Camden Residents' Action Group

Re: Planning Proposal (PP 2020)
Concept development application DA 2020/524
5 Smalls Road, Grasmere
Lot 201 DP 734620

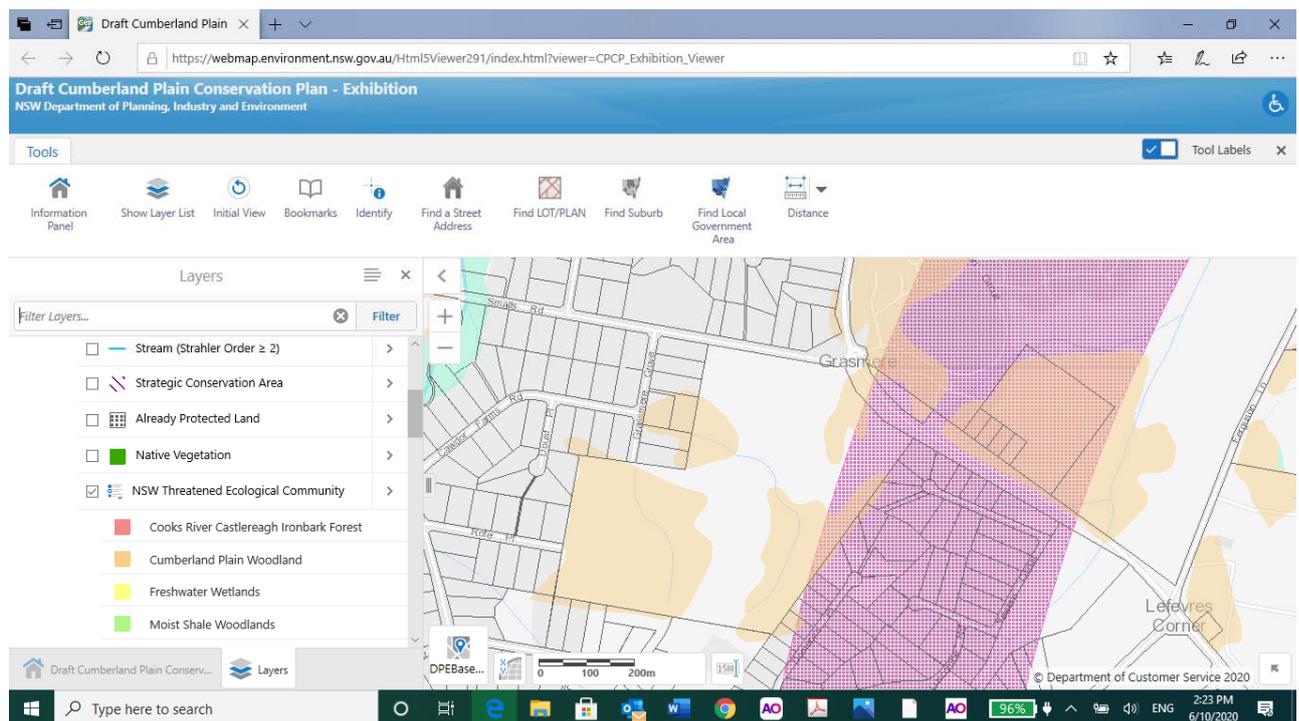
It is not possible to reasonably argue that the height and density of the proposed development would blend with its surrounds and be consistent with adjoining development.

PP 2020 Architectural Public Plans (p3)

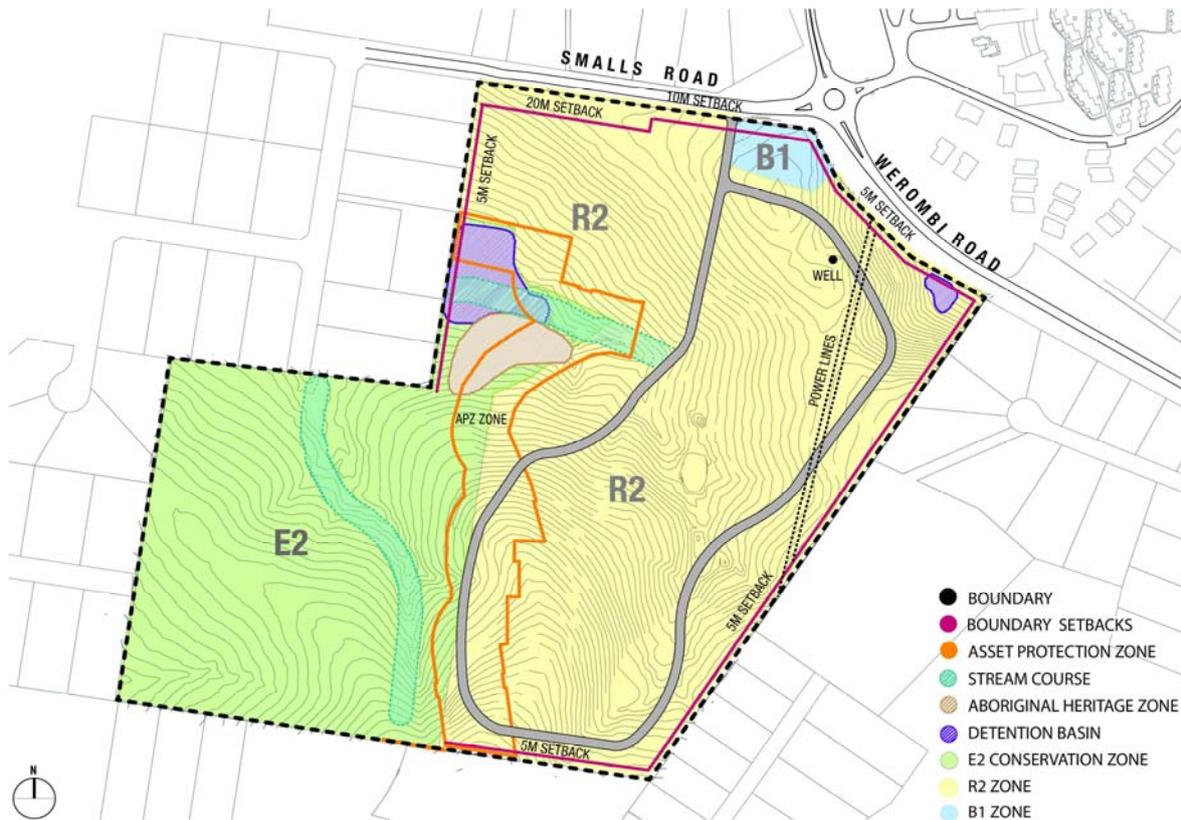
This 2013 Assessment report records a number of finds, most concentrated in site C4¹⁵ which is noted as Aboriginal Heritage Zone shaded brown in the 2020 Architectural Public Plans below.

Nevertheless, the 2020 Architectural Public Plans as shown above clearly shows that much of the Aboriginal Heritage Zone is also within the APZ which would suggest future difficulty in avoiding disturbance of much of the Aboriginal Heritage Zone.

How can much of the Aboriginal Heritage Zone avoid disturbance being within the APZ?

2012 Indicative Layout Plan ¹⁷

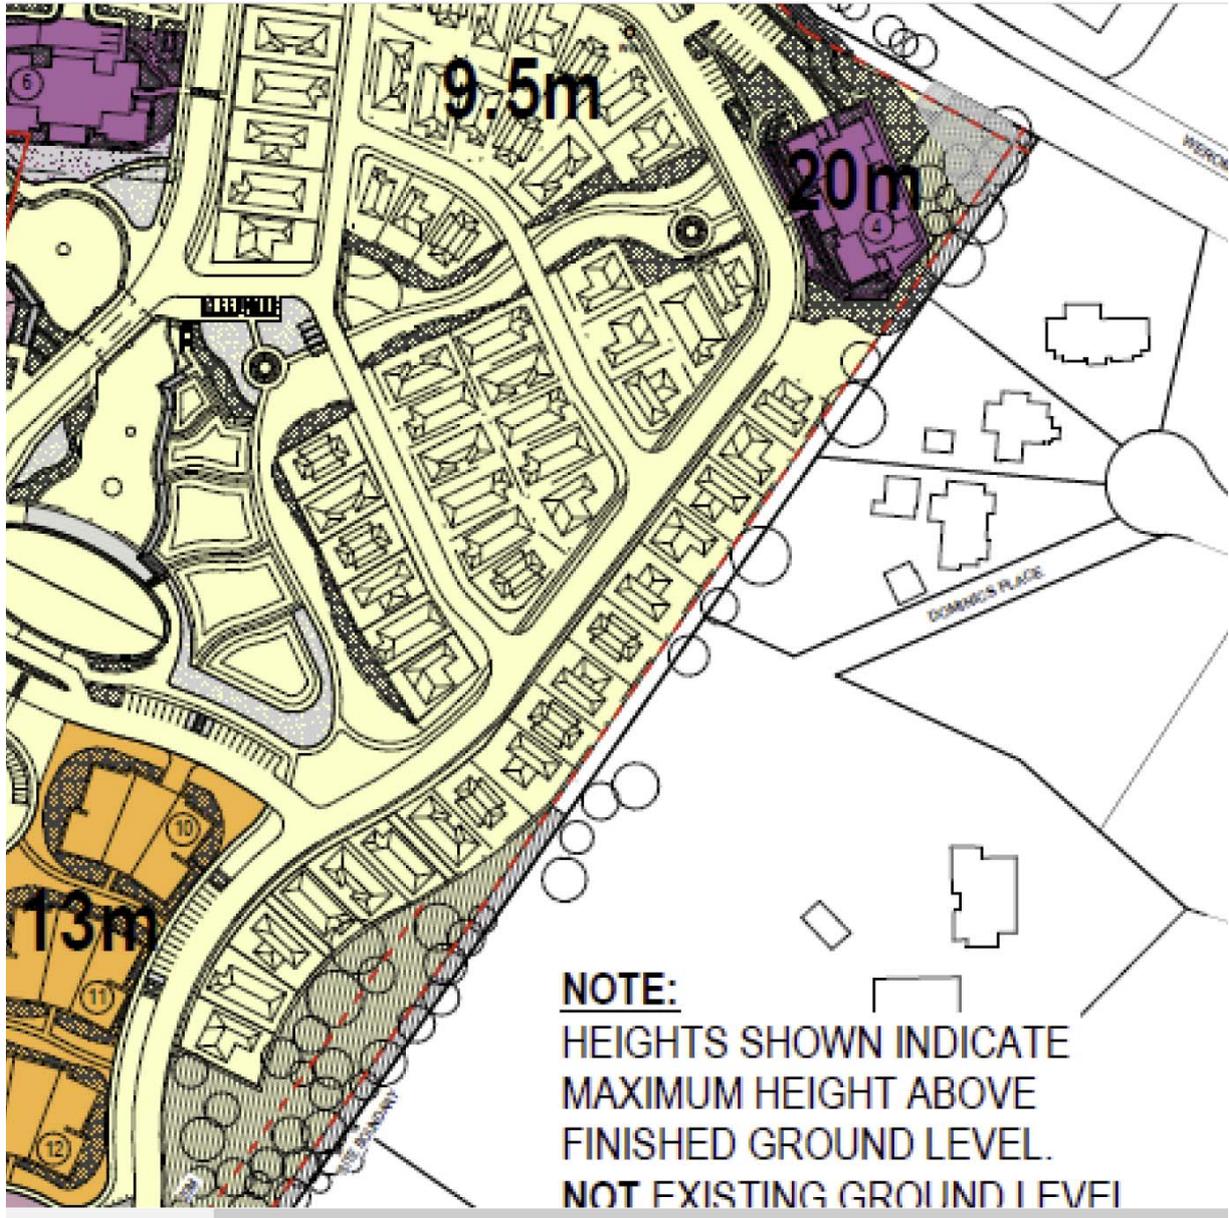
Many affected Grasmere residents have watched the evolution of the Proponent's intentions for this site over the years. In 2012, as shown below, the Planning Proposal presented an ILP that provided a greater buffer with neighbours and was less intrusive in the landscape.

Residents understood from previous iterations that most trees were to be retained, including all trees on the boundary with their properties. This understanding is corroborated by the 2012 ILP shown above.

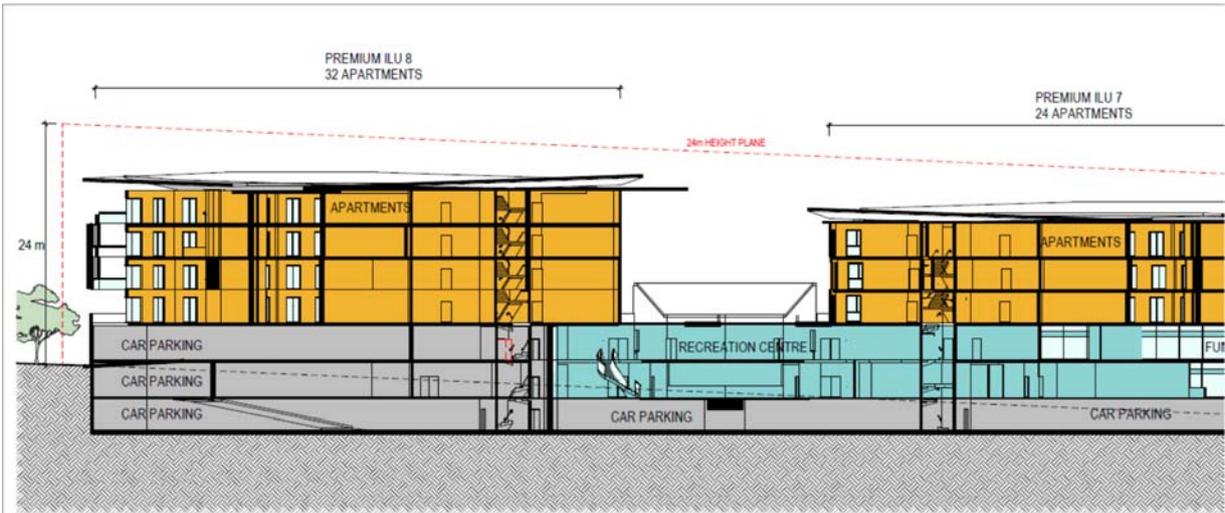
As can be seen in the recent photos of a couple of these residences below, CPW is not only critically endangered but is also an important buffer and intrinsic characteristic of the semi-rural area.

Retention of any trees outside E2 is subject to a future arborist report. The proposed development is now as little as 5 metres from the rear of these Grasmere properties with dwellings being built within 10 metres. Residents understood that the previously stated limit was 20 metres. There can

CPW at the rear of properties is a valuable buffer zone and eco-system between the development and current residential lots. It is home to many species of fauna including prolific birdlife and many kangaroos/wallabies, echidna and reptiles.

1 RECREATION CENTRE & PREMIUM ILU8 - LONG SECTION
SCALE 1:200

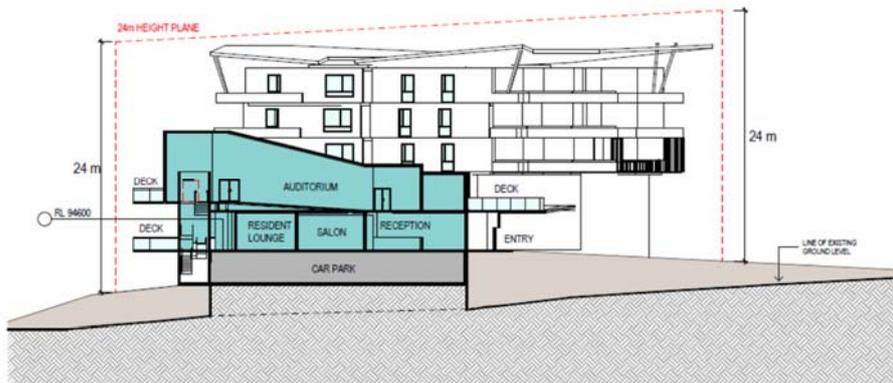
The Architectural Public Plans show maximum height relating to 24m as above finished ground level, not existing ground level, and the publicly available architectural diagrams, some of which are included below, clearly demonstrate the impact of building height and number of stories.
